**REQUEST FOR TENDER  
AFRICA PAVILION – WASHROOM UPGRADES  
RFT No.: TZC T 26-2020-03**

**ADDENDUM 6**

**REFLECTED CEILING PLAN**

**A203**

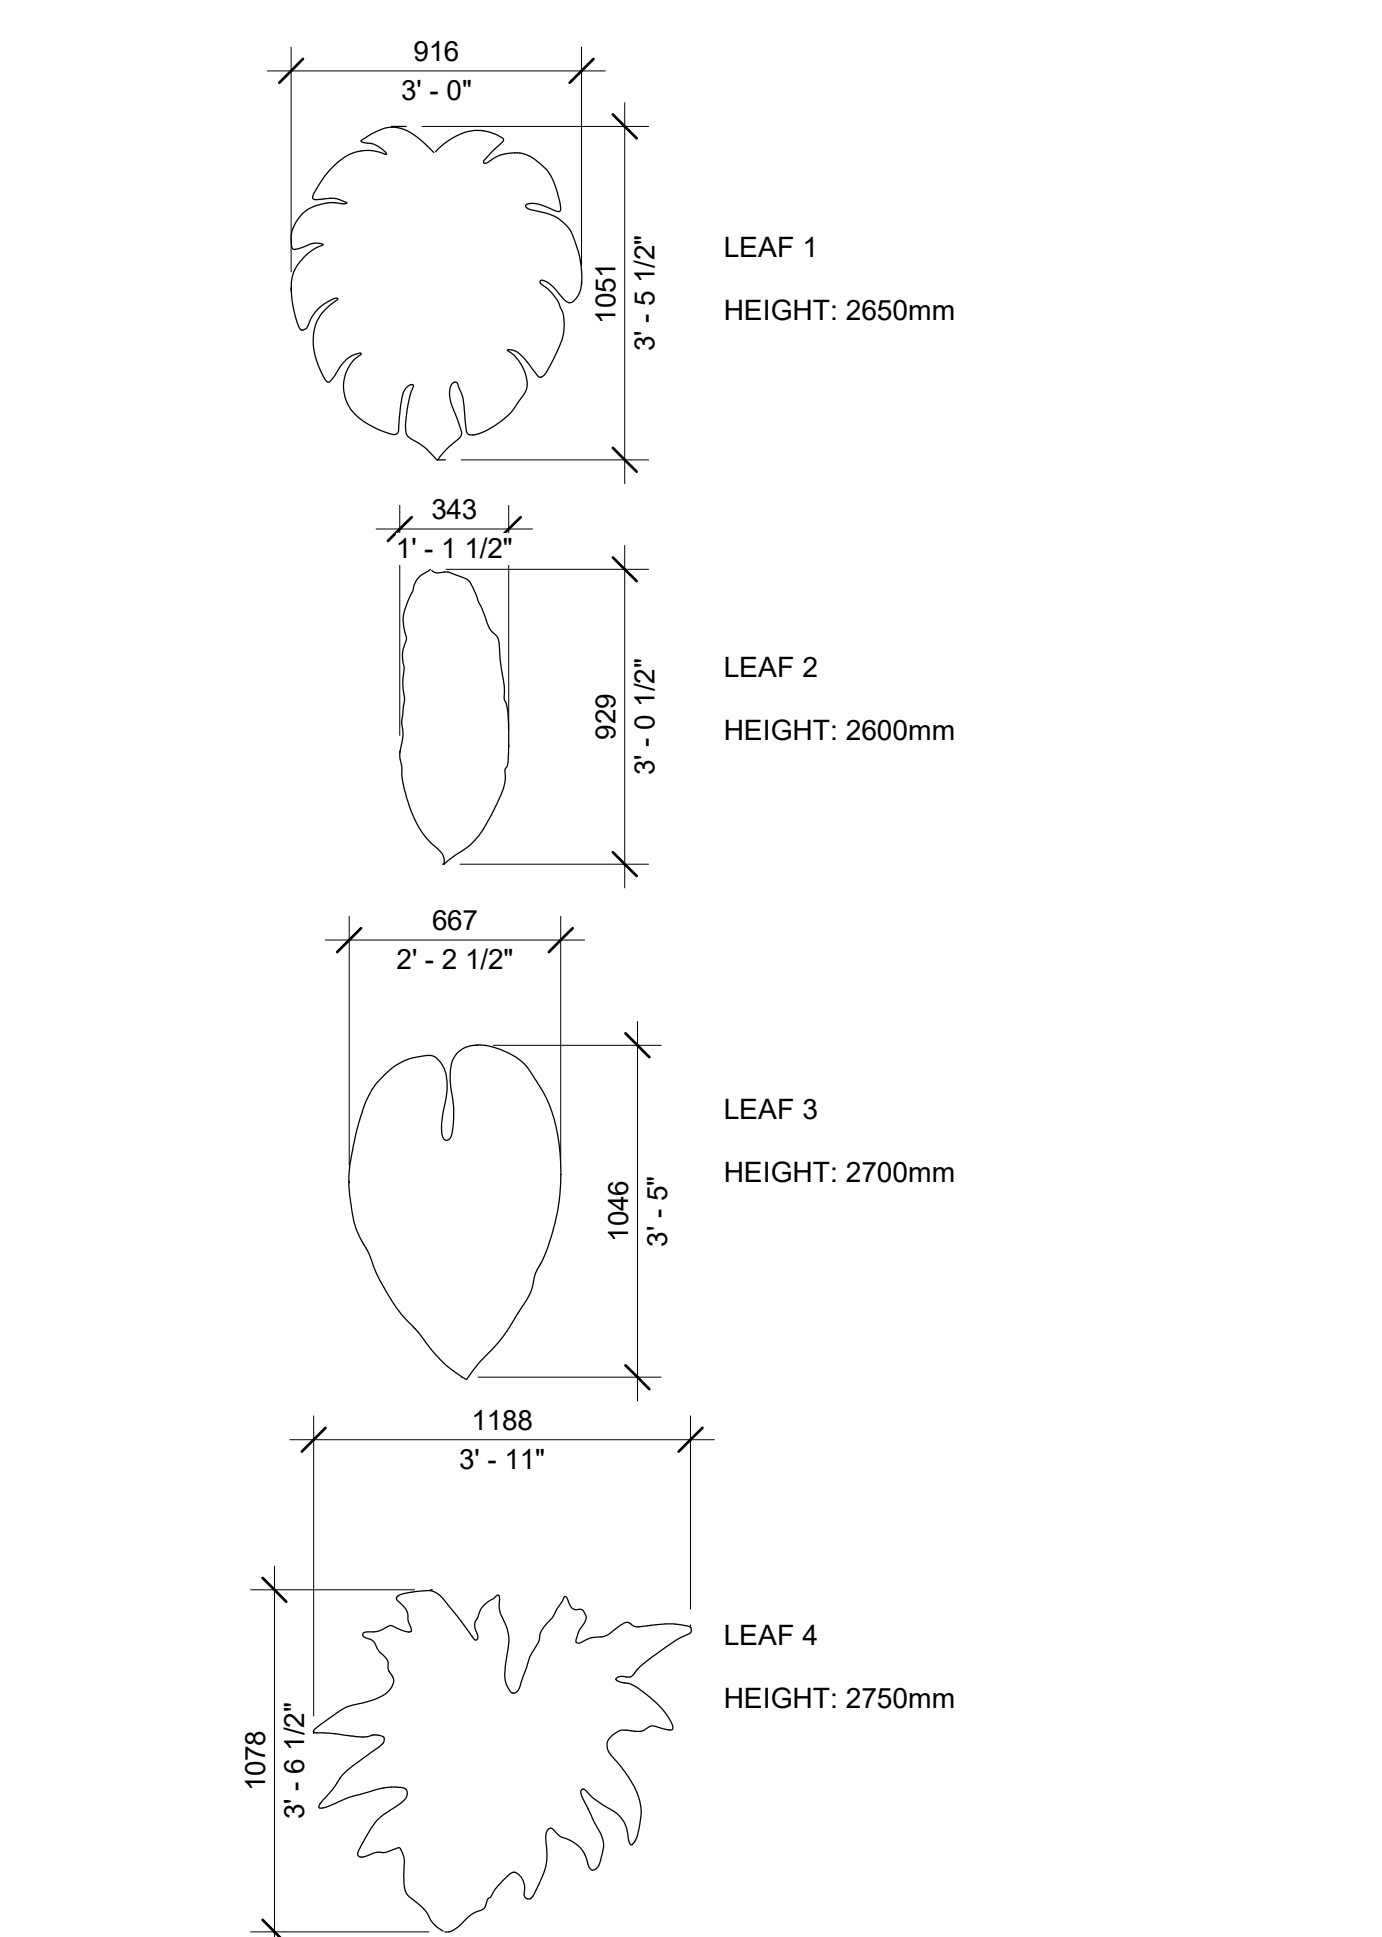
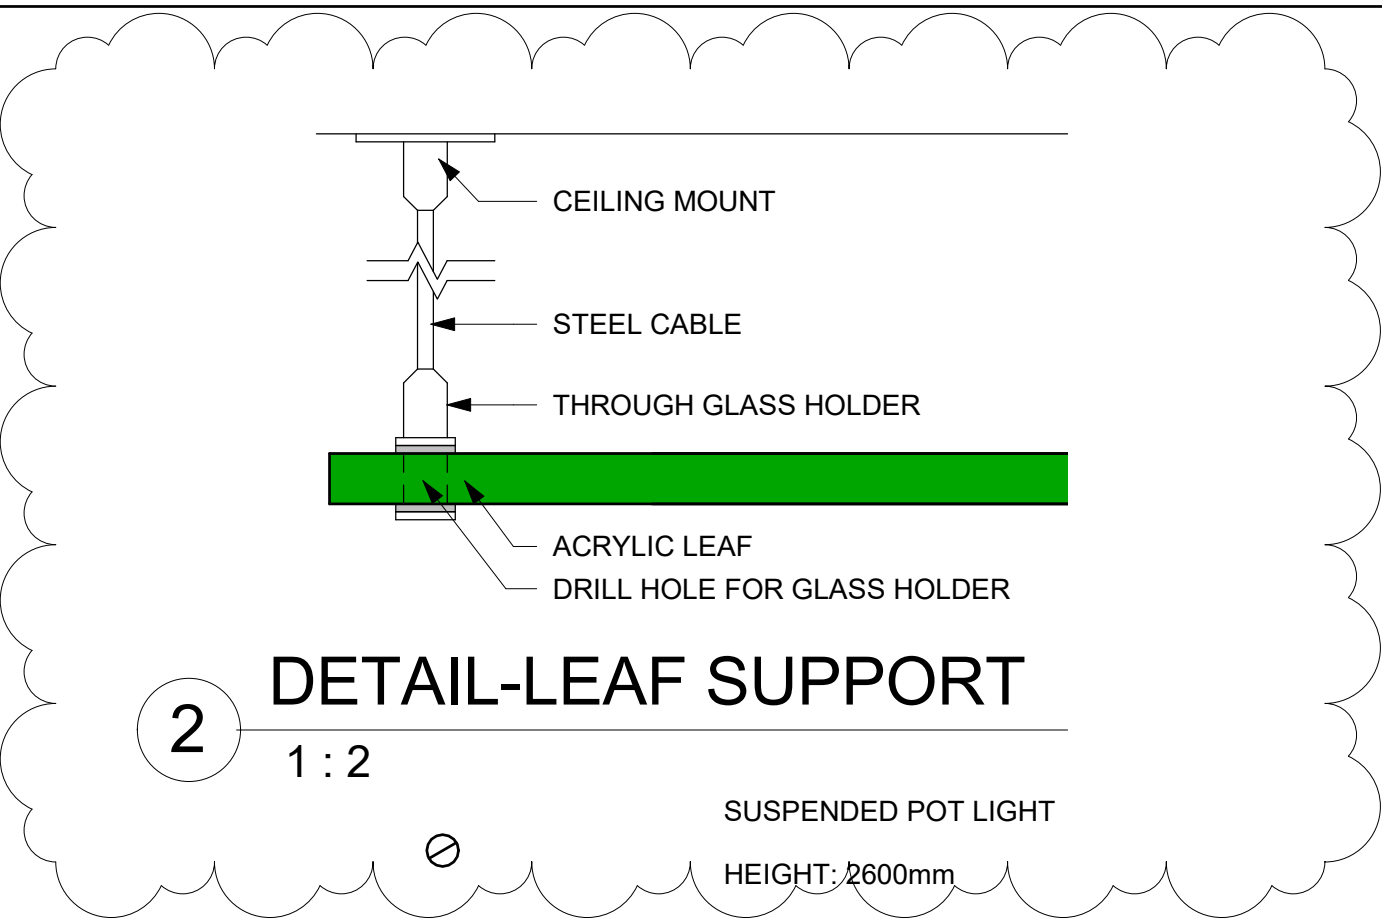
Who will supply Translucent Plexiglass Acrylic Leaves Sheet? If supply by GC, Can you please provide specification for those leaves sheet?

The GC is responsible for the supply and install of these custom translucent plexiglass coloured sheets, which are cut to the leaf profiles as illustrated. Please reference the notes on the drawings.

- NOTE:
- LEAVES ARE TO BE MADE OF TRANSLUCENT PLEXIGLASS COLOURED ACRYLIC SHEETS THAT ARE CUT TO THE LEAF PROFILES AS ILLUSTRATED. LEAF TEMPLATE CAN BE PROVIDED AT CONTRACTOR'S REQUEST OR A SIMILAR PROFILE CAN BE SUBMITTED FOR CONSULTANTS REVIEW

- TRANSPARENT PLEXIGLASS SHEETS TO BE A MINIMUM OF 1/4" (6mm) THICK.
  - COLOUR OF LEAVES TO BE A VARIETY OF GREEN FROM LIGHT GREEN TO DARK GREEN. THREE GREEN COLOURS ARE TO BE SELECTED AND ARE TO BE CUSTOM COLOURED.

- LEAVES TO BE SUSPENDED FROM CONCRETE CEILING SLAB UTILIZING CABLE SYSTEM SUCH AS THE ORL CABLE DISPLAY SYSTEM OR APPROVED EQUIVALENT
  - HEIGHT OF LEAVES TO RANGE. AS THERE ARE FOUR LEAF PROFILES, EACH PROFILE SHALL BE INSTALLED AT A DIFFERENT HEIGHT RANGING IN 50mm +/- INTERVALS.
